ADDENDUM NO. 1

Project Name: IRC-2201: Waters Edge Culvert Replacement

Bid Number: 2024046

This addendum is being released to provide the pre-bid meeting minutes and sign-in sheet, answer bidder questions received to date, and modify the bid documents.

PHASE I - 60" RCP INSTALLATION AND DEWATERING PLAN AT 37TH DRIVE S.W.

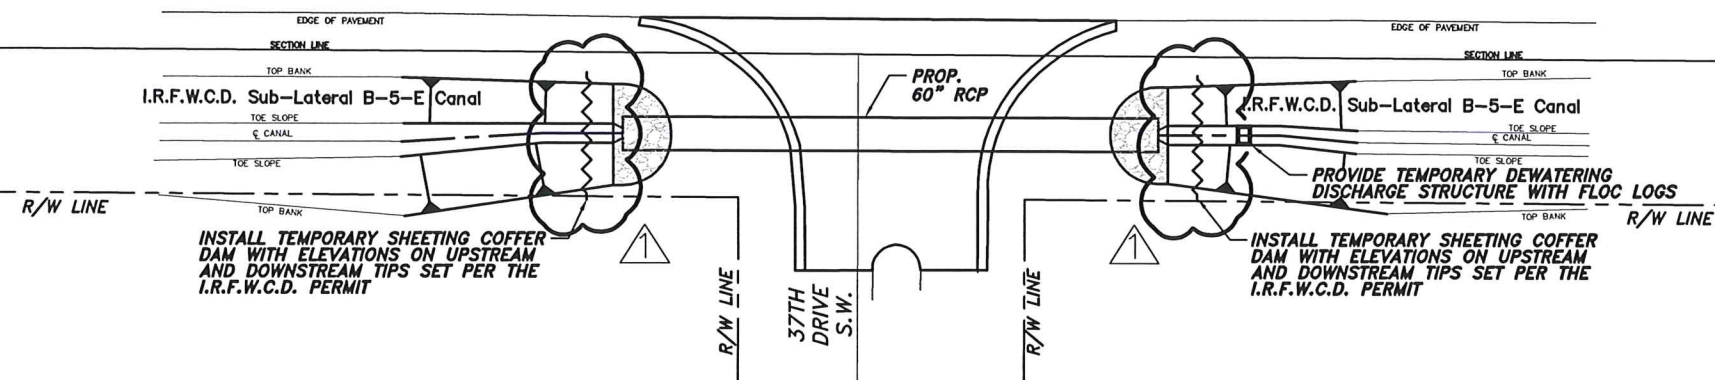
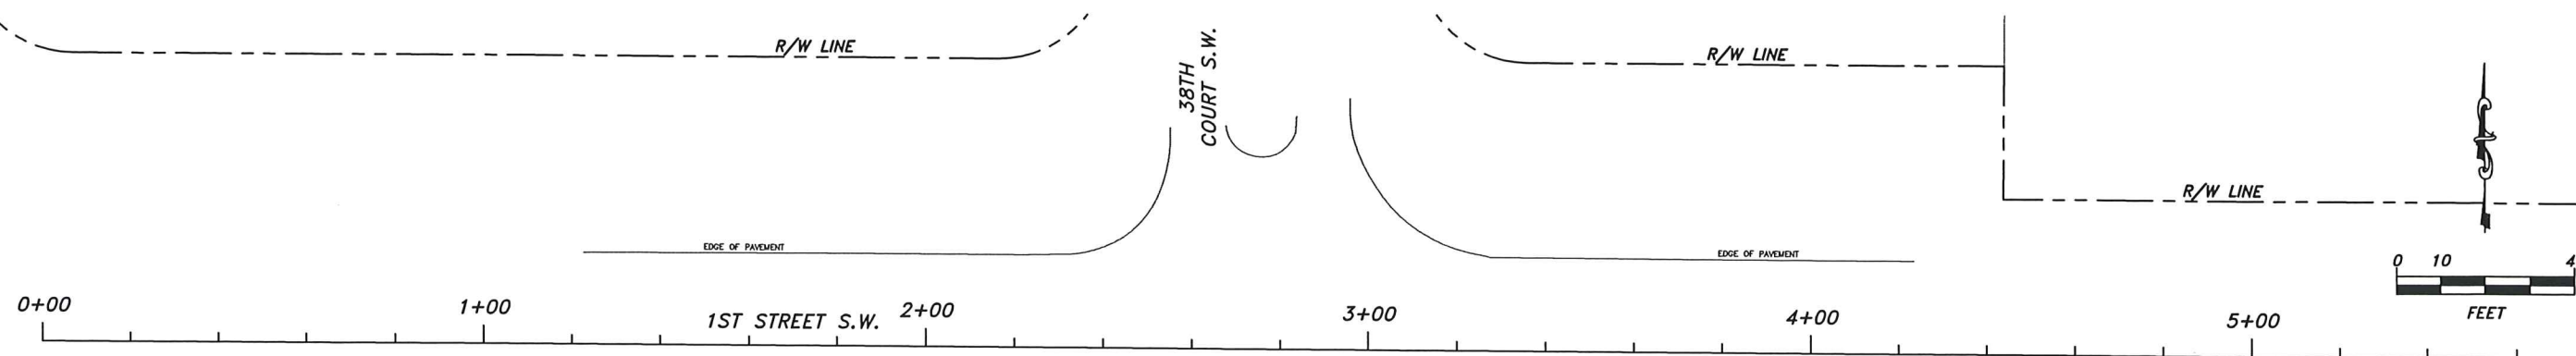
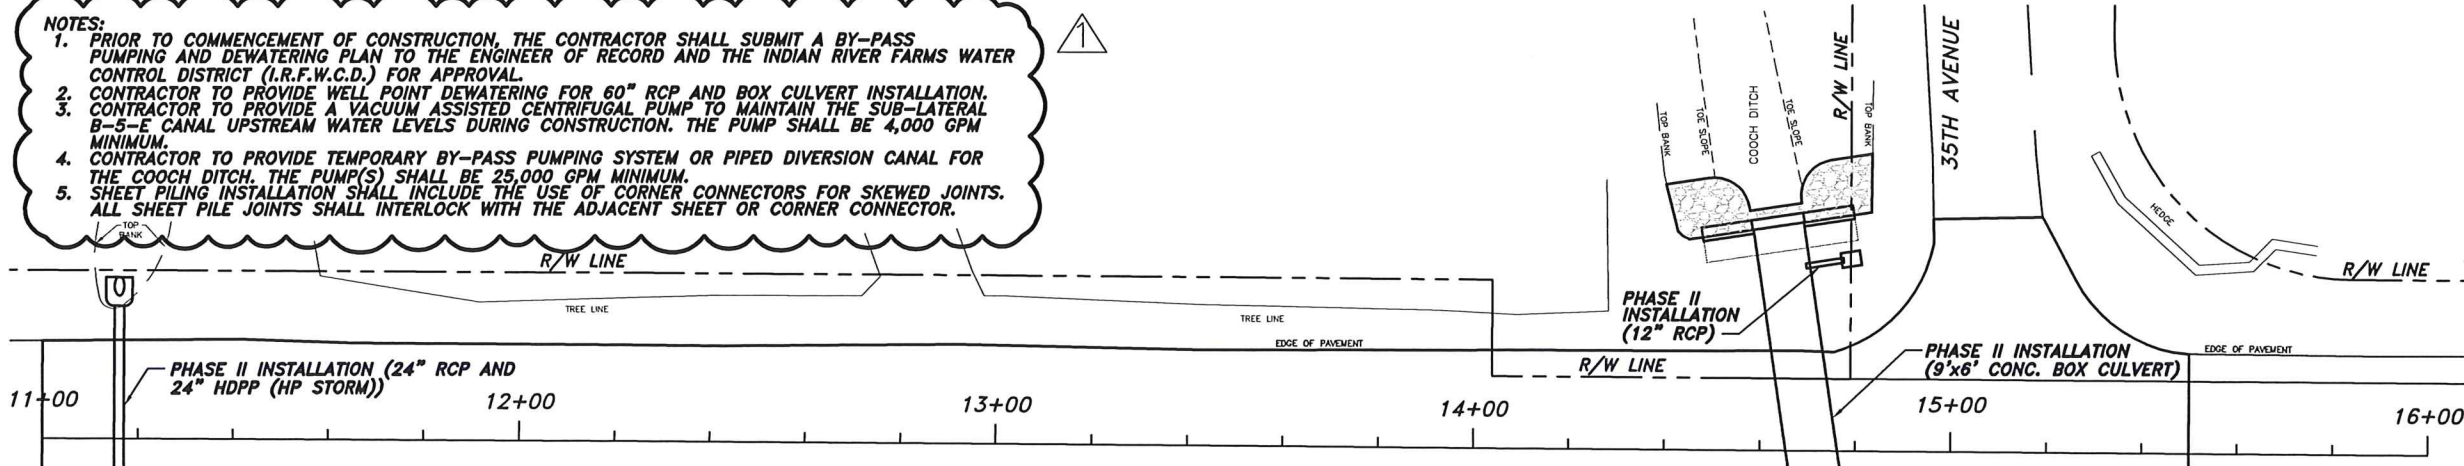
3. Is steel sheeting required on all the canals, in each direction? **Steel sheeting is required on a minimum of 3 sides for the box culvert installation and only on the ends for the 60-inch culvert installations.**

PHASE II - BOX CULVERT INSTALLATION AND DEWATERING PLAN AT 36TH COURT S.W.

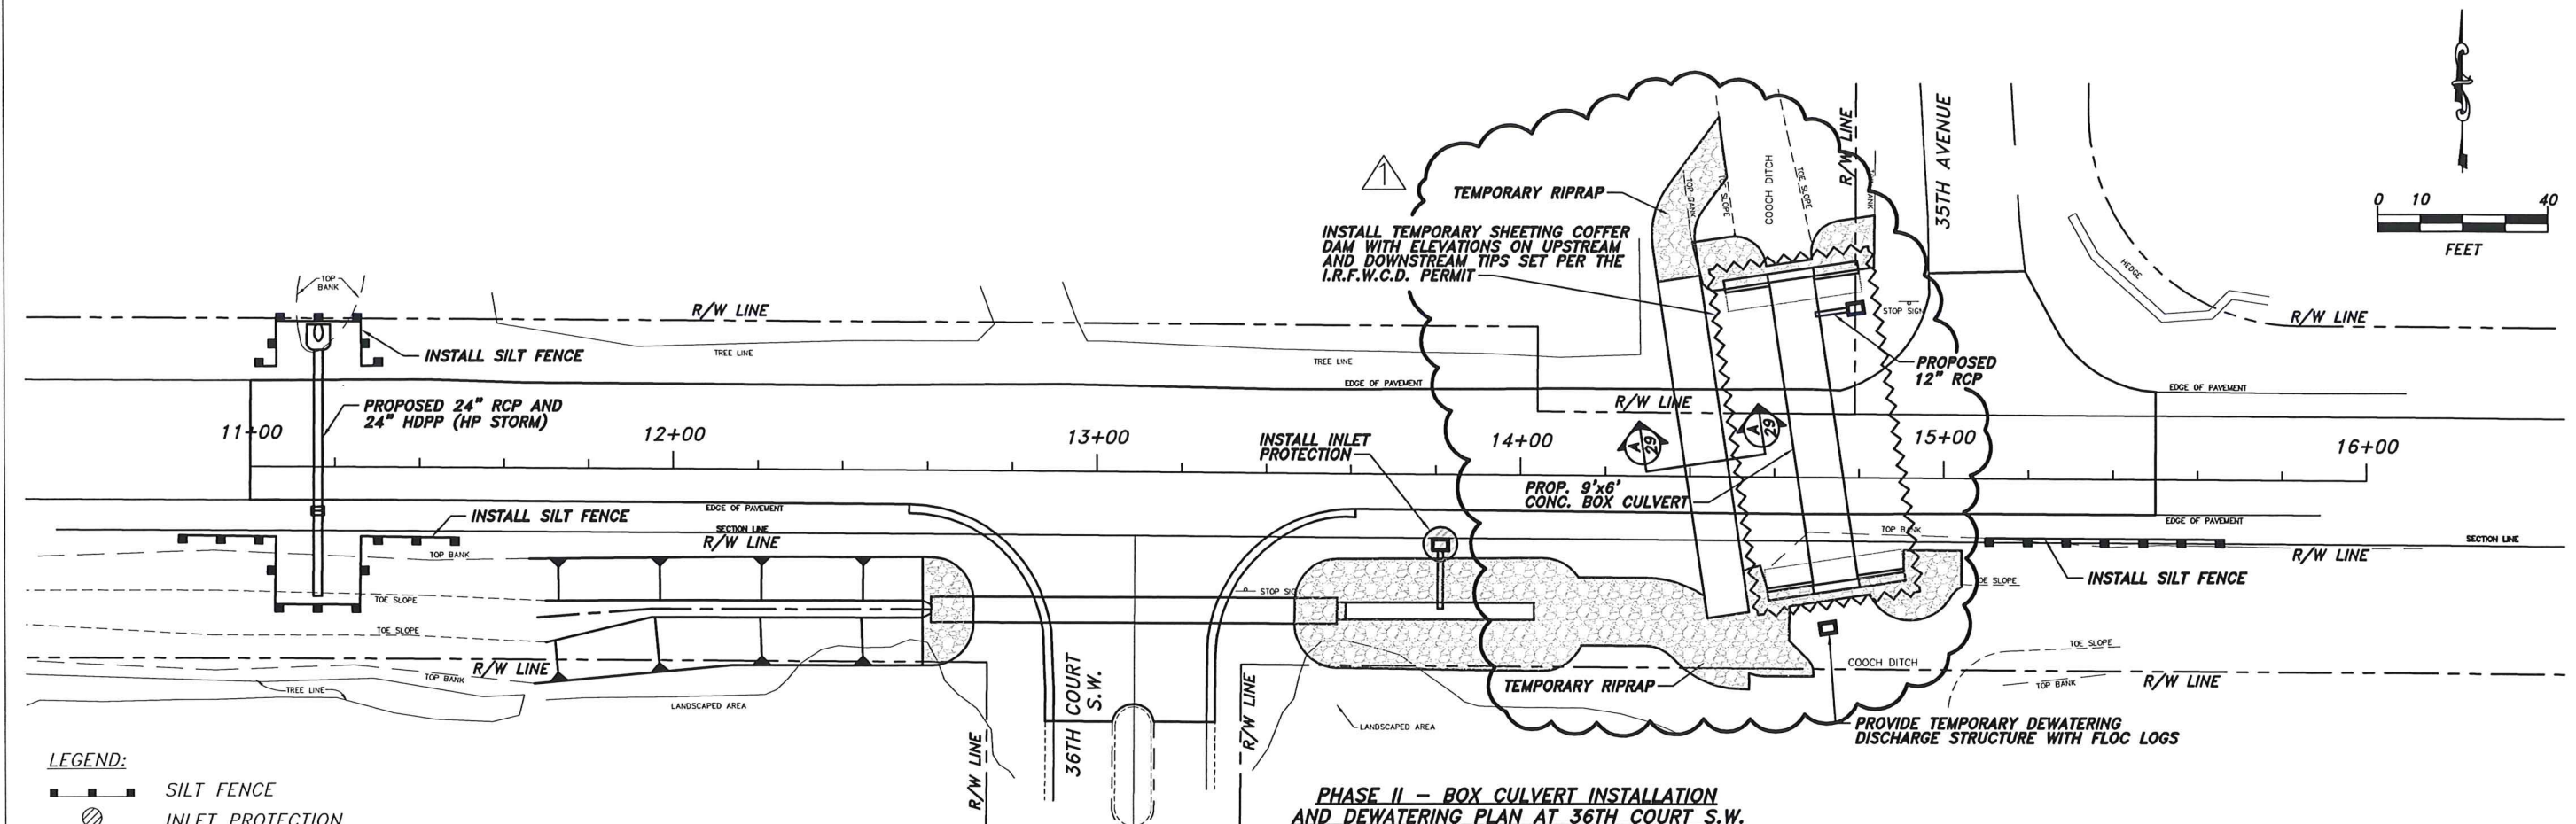
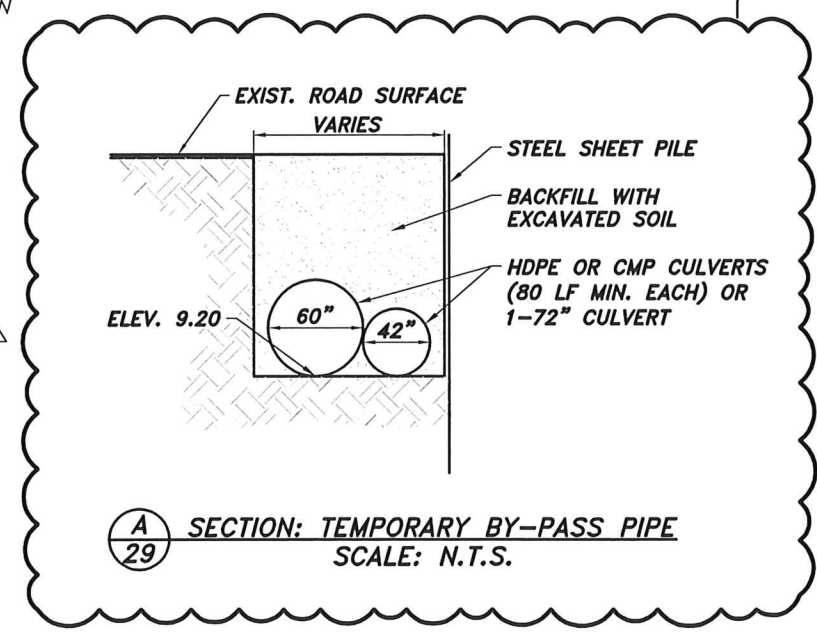
8. Is there a problem with working on both phases at the same time? **See answer to Question 7.**
9. Would a pair of 42" pipe be accepted in lieu of the 72" pipe? **A 60-inch and 42-inch pipe can be installed side by side and is equivalent to a 72-inch pipe. See plan Sheet 29 of 30 Addendum 1.**
